## Report to Sydney Central City Planning Panel

<b>SCCPP reference</b>	PPSSCC- 361
<b>DA No.</b>	493/2020 - Section 8.3 Review
<b>Date of receipt</b>	31 August 2020. Amended plans or revised/additional information received: <ul style="list-style-type: none"><li>• 9.8.22</li><li>• 28.9.22</li><li>• 6.10.22</li></ul>
<b>Proposal</b>	Construction of two residential towers comprising 708 apartments above the existing seven storey podium, the use of existing basement levels 1-5 for residential parking and various adjustments to the existing building to allow for the integration of those towers.
<b>Street address</b>	189 Macquarie Street, Parramatta
<b>Property Description</b>	Lot 1, DP 1214839
<b>Applicant</b>	Toplace Pty Ltd
<b>Owner</b>	JKN PARA Pty Ltd
<b>Submissions</b>	Less than 10 unique submissions
<b>Relevant s4.15 matters</b>	<ul style="list-style-type: none"><li>• Environmental Planning and Assessment Act and Regulations</li><li>• State Environmental Planning Policy (Resilience and Hazards) 2021</li><li>• State Environmental Planning Policy No. 65</li><li>• State Environmental Planning Policy (BASIX) 2004</li><li>• SEPP (Transport and Infrastructure) 2007</li><li>• SEPP (Stat

Figure 9: Plan view of corridor treatment

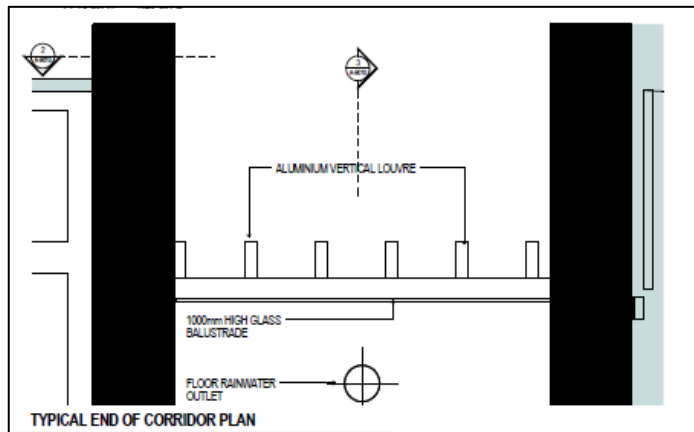
- Substantial parts of the common corridors in both Towers A and B, as shown in the following figures

The justification for excluding these corridors from a GFA calculation is a design whereby the end of a corridor is "open to the weather" to allow for a semantic compliance with the LEP definition of 'gross floor area'. That treatment comprises fixed vertical louvres, independent from which sits a 1m glass balustrade, as shown below:

While it is acknowledged there would be certain genuine examples of where an external circulation corridor should be excluded from a GFA calculation, adopting that same approach for corridors which are essentially internal and proportionally insignificant within the overall façade, like those of this scheme, is a disingenuous design exercise which does affect building bulk, and provides a poor amenity outcome for residents.

Figure 11: Study location 12, 13,14 and 18 in red. Private property landscaping shown in yellow.

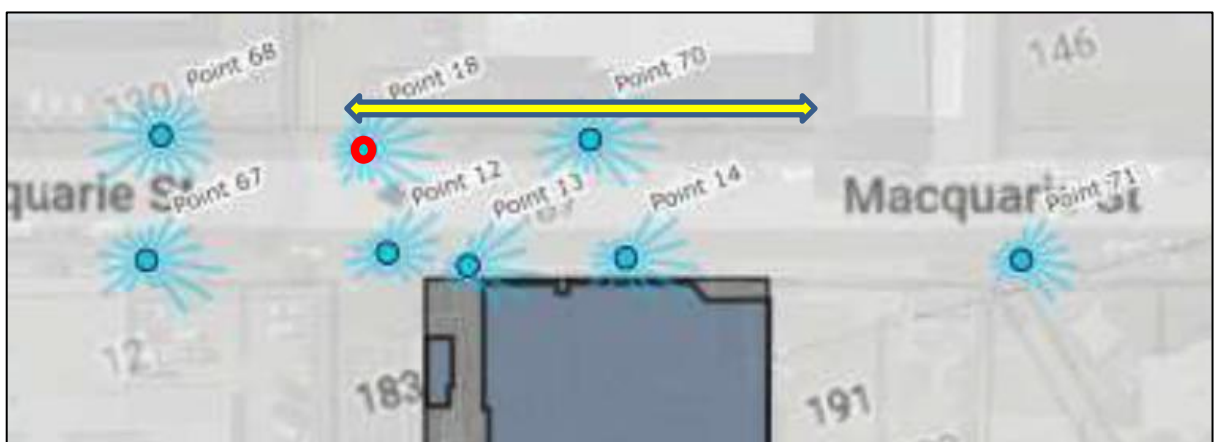
- Location 18 of the wind impact assessment is on the northern side of Macquarie Street, as shown at Figure 11. Preceding technical reports indicated a reliance upon landscaping to mitigate impacts at location 18. However as there are no street trees, only trees on private property are available for that purpose. Given the applicant has no control over the retention of that vegetation, such a circumstance is not acceptable.

Figure 13: Extract from wind report showing location of screen for mitigation to Macquarie Street

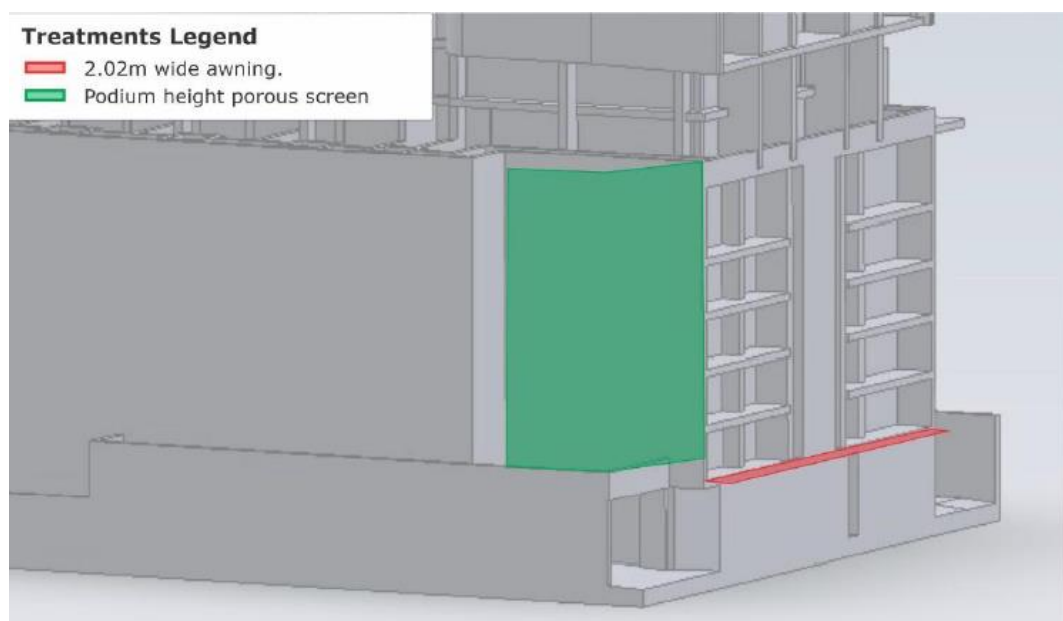
- A permeable upturn screen over part of the podium is required to mitigate wind conditions along Macquarie Street (at locations 12,13,14 and 18 – refer Figure xx above)

Although the need for the screen was identified with the original DA, it was understood to be 6m high, but was never documented on any plans.

The concerns with the introduction of this element into the design of the building are:
